## North Somerset Council

### Transport and Highways Summary Comments

#### Application 18/P/5118/OUT

**12 November 2019**

Figure 7 – Forecast demand for spaces in March / December 2017 to 2026

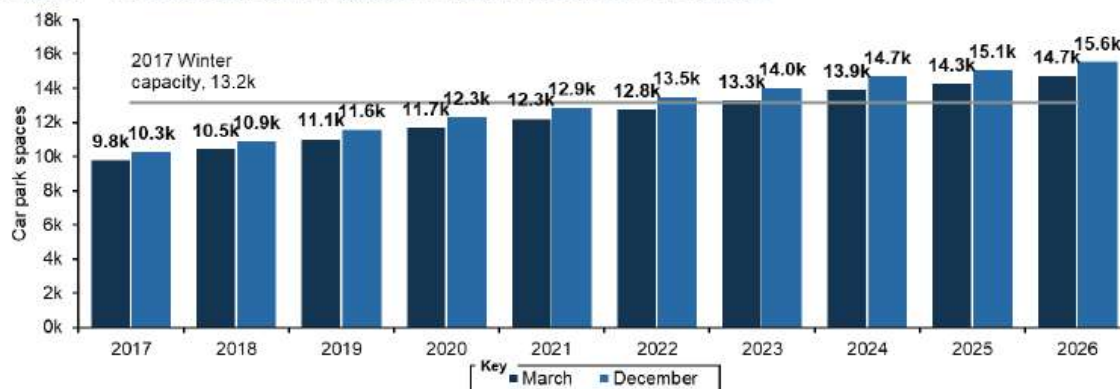
The figure above from the Addendum Report highlights the forecast peak demand for spaces in the winter of 2026 and compares it to winter 2017 capacity. The figure demonstrates that from 2022 the peak December demand will exceed the 2017 winter capacity. The report proposes the operation of the Silver Zone temporary seasonal extension (C1) and a proposed extension to the south of C1 (C2) on an annual basis to accommodate fluctuations in demand for and provision of on-site parking.
